Attachment C

MHRC SUPPORT BUILDING - PROPOSED CONCEPT PLAN

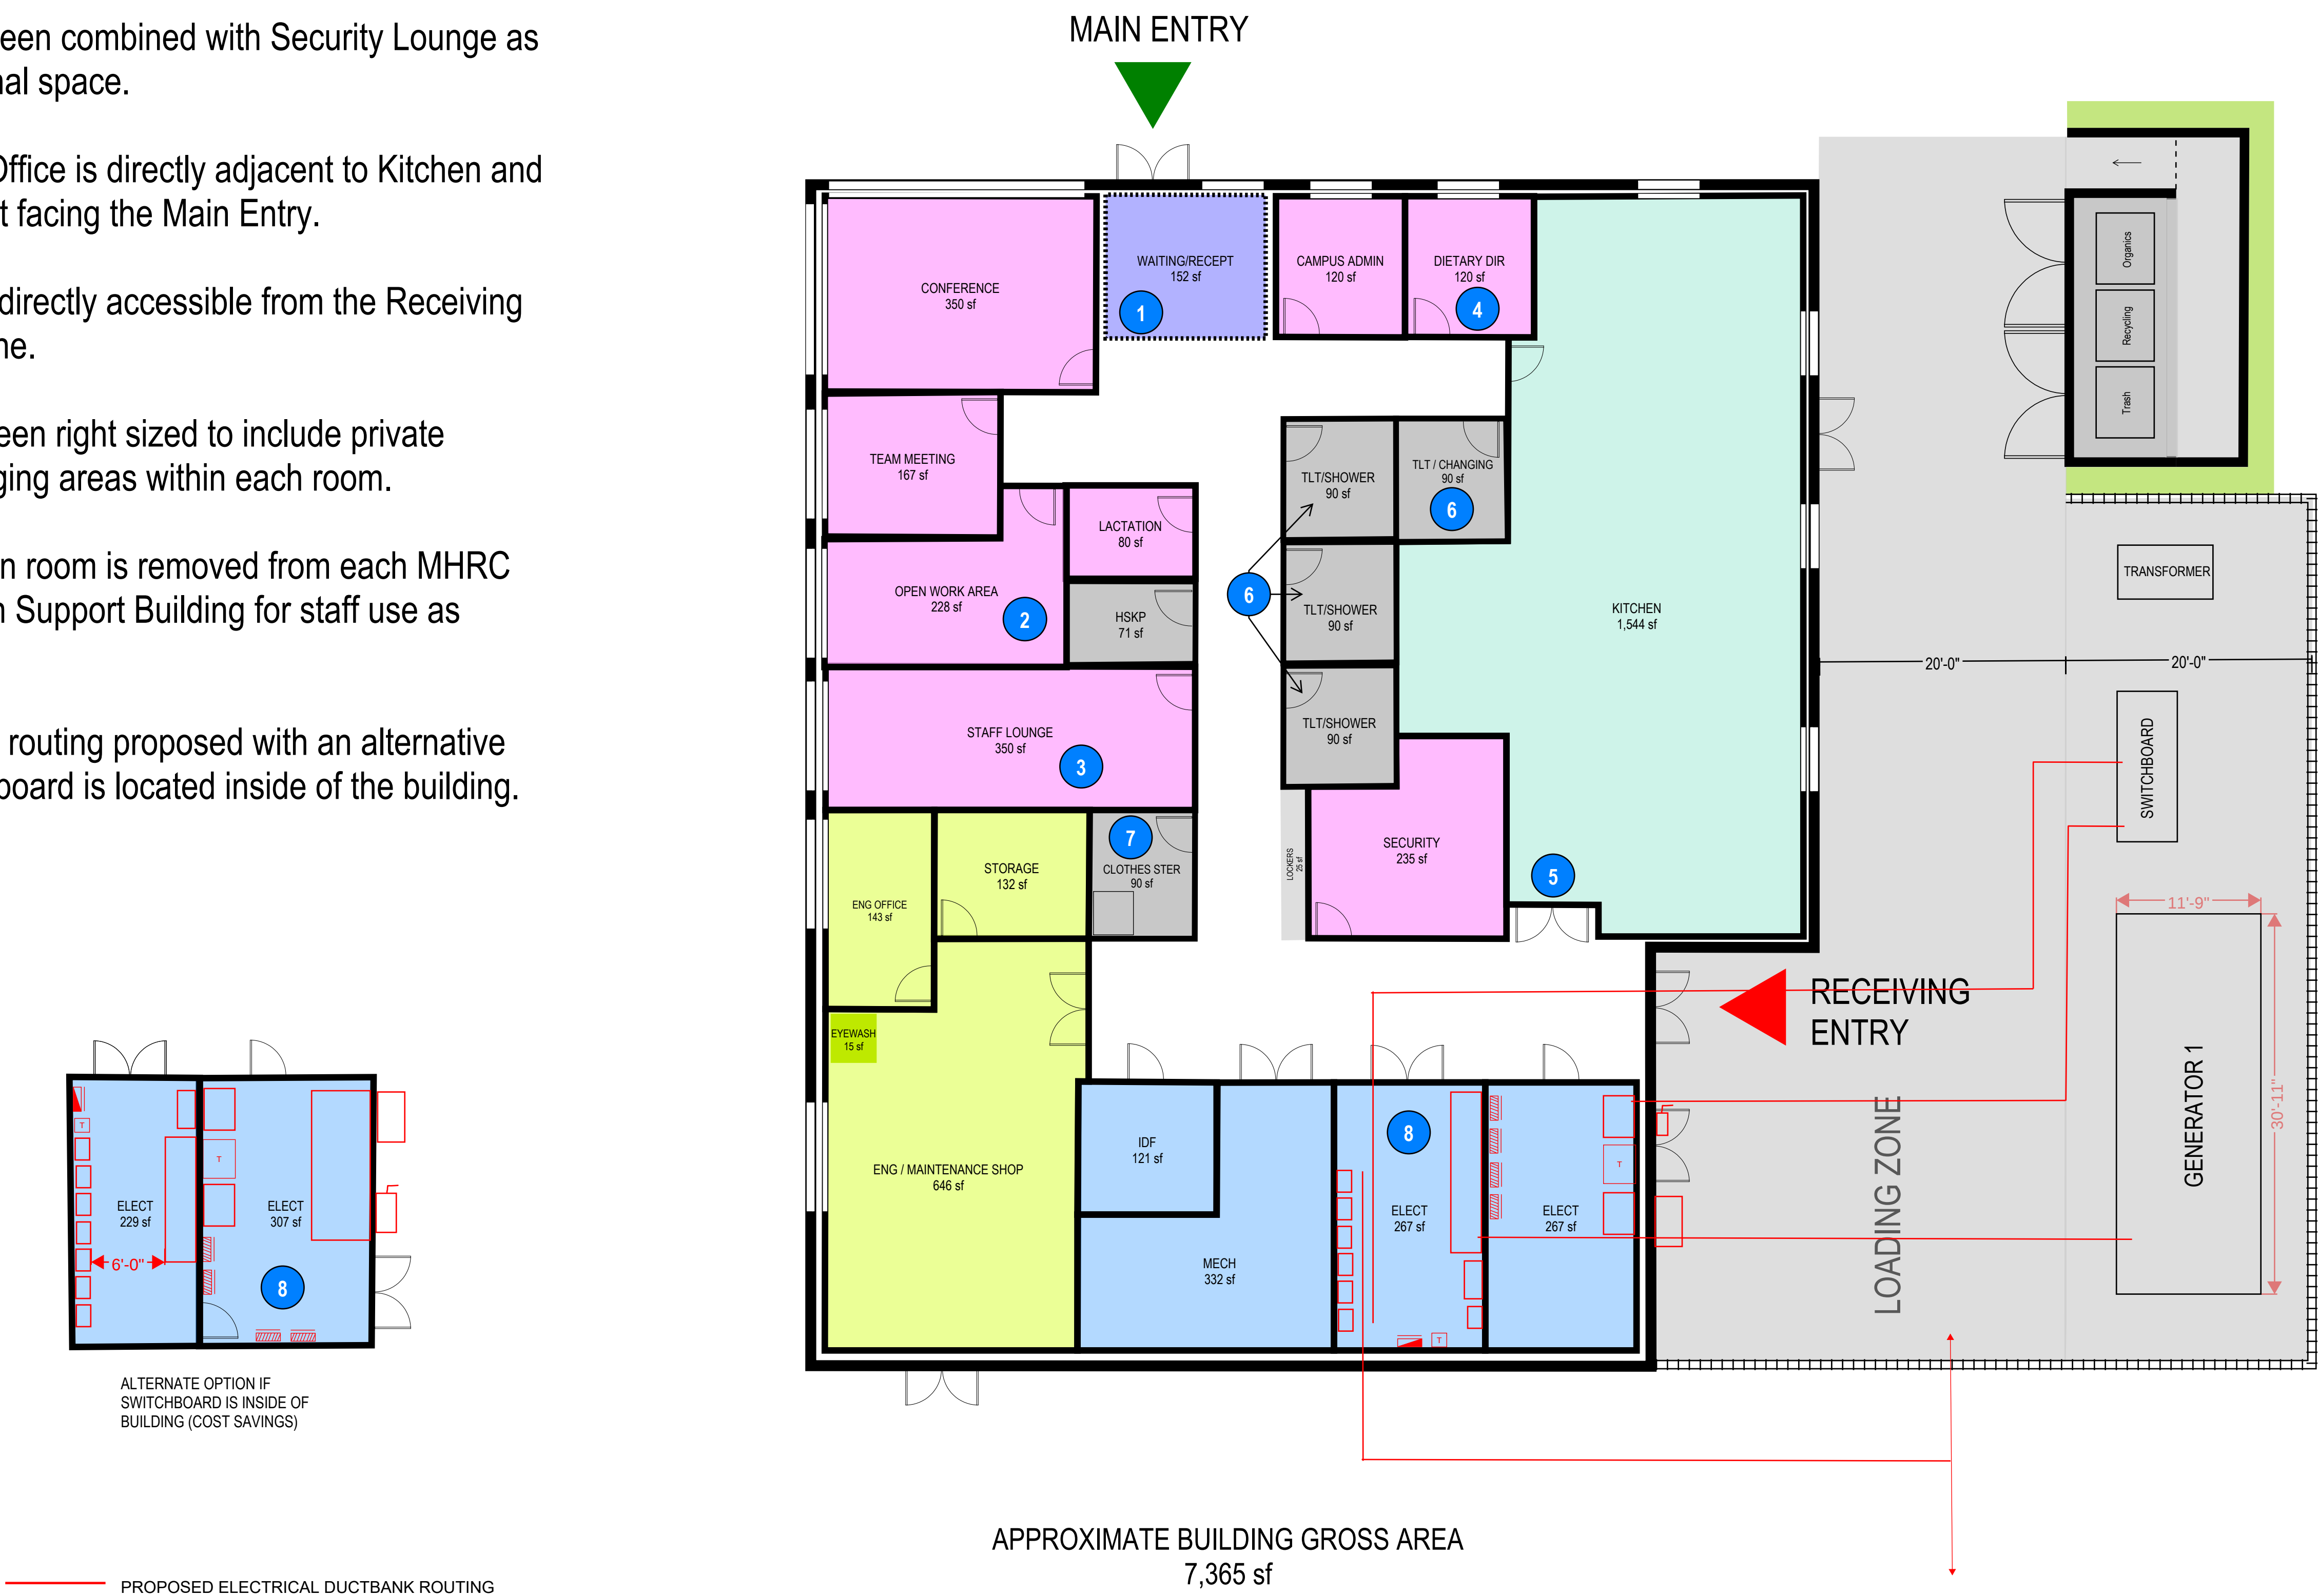
- 1 Sallyport entry location maintains original San Mateo MHRC location. Clients will have visibility to incoming visitors and new clients from the east bedrooms. Entry and Meditation areas are adjusted to maximize corridor space upon entering through the Sallyport.

- 2 Staff Work Area size is maximized with new arrangement of Kitchenette in the Staff Lounge. Staff have full visibility throughout the MHRC with centralized work area location.

- 3 Optional staff only access door added directly into Exam/Consult for medication distribution. New Medication Room location includes a walk up window for client distribution if desired.

- 4 Kitchenette has been moved to Staff Lounge Room instead of previous corridor location. Egress only door through Staff Lounge is maintained.
- 5 Daylight openings are maximized in staff offices located on front face of the building. Staff have better site visibility offering additional security of site.

- 6 Building services components have been enlarged per MEP requirements and can have optional exterior doors for direct access.
- 7 Housekeeping is directly accessible in staff corridor, maximizing Dining/Activity and Nourishment areas. Storage Room is accessed directly from Nourishment Room.

- 8 Clothing Sterilization is removed from each MHRC and planned for placement in the MHRC Support Building. Area is given back to staff program.
- 9 Laundry will be a staff only area, clients in this facility are not expected to perform laundry services as part of their treatment program.

- 10 New Staff Offices enhance visibility within client bedroom wings and offer closer access to the courtyards.
- 11 Building geometry is simplified for ease of construction and potential cost savings.
